**I STRONGLY OBJECT TO THE PROJECT . - The Norwich to Tilbury Upgrade project brings severe harm to the environment, communities, landscapes & heritage of East Anglia. I support the views held by the Essex and Suffolk Pylons Action Group.**

**The comments below apply to Section C- Underground element from the 'Sealing In' Compound in Raydon to the river crossing at Stratford St Mary:-**

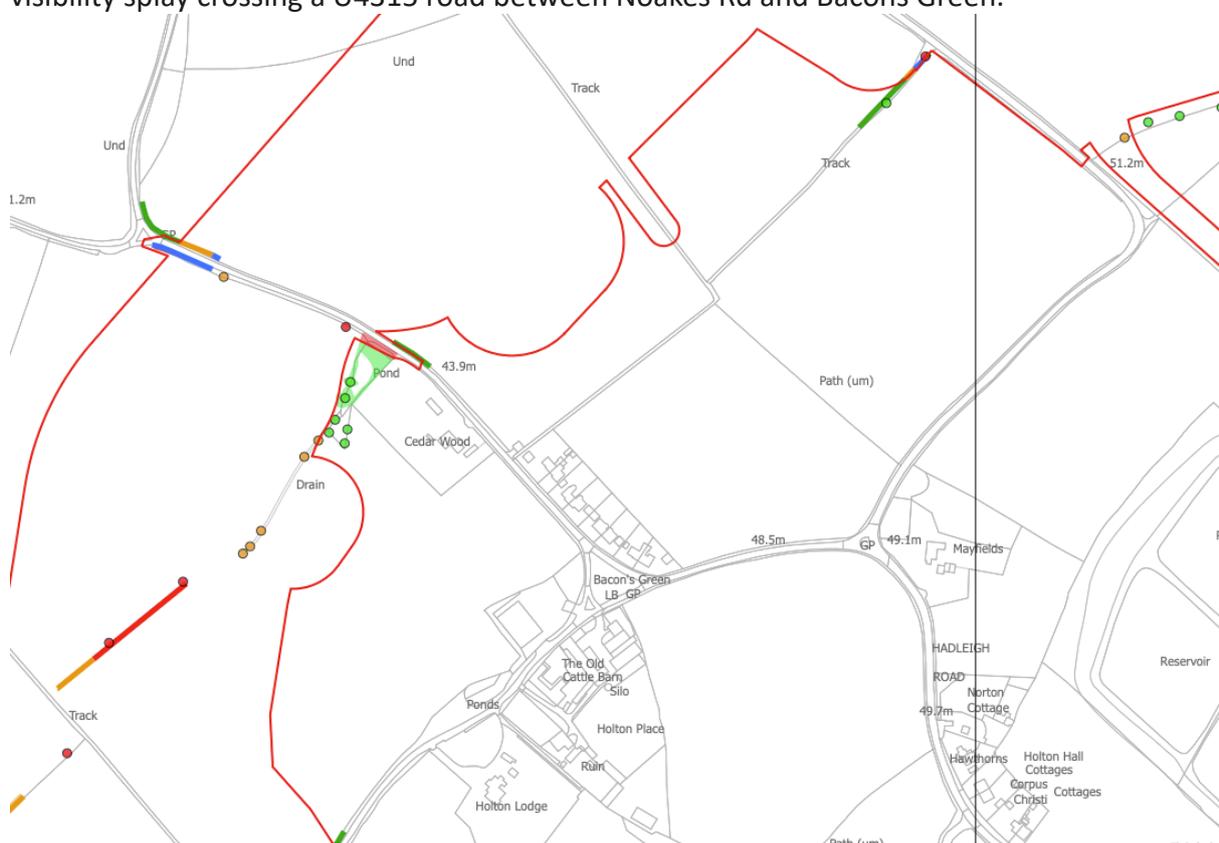
There is no control on the direction of approach of a disabled aircraft to the Airfield so the **Cable Sealing in Compound in Raydon should be moved further north to near Pylon JC26 as a MINIMUM to maintain a clear safe approach from ALL directions to Raydon Wings Airfield.** This has the added benefits of utilising Wenham Thicks as a natural screen and changing the access route viability (see dismantled railway access route suggested above) with the few properties affected at Bottle Bridge Corner on Wenham Road being screened by mature trees.

**The Electricity Act (1989)** Requires National Grid, when formulating proposals for new lines and other works, to: *have regard to the desirability of preserving natural beauty, of conserving flora, fauna, and geological or physiographical features of special interest and of protecting sites, buildings and objects of architectural, historic or archaeological interest; and shall do what [it] reasonably can to mitigate any effect which the proposals would have.* It must be noted that the desirability of conserving 'natural beauty' is not confined to nationally designated landscapes. **The Materials Lay Down Area and Construction Compound (JC CC02) planned for the B1070 / Acacia Road junction will be clearly visible from the Dedham Vale National Landscape, an area renowned for its tranquillity and lack of industrial development. In the light of this the Construction Compound must be moved from the highly visible Acacia Road location onto Notley Enterprise Park (disused Raydon Airfield), North of the originally proposed Materials Lay Down Area to place it adjacent to an Industrial area, already having some infrastructure and partially screened by existing planting.**
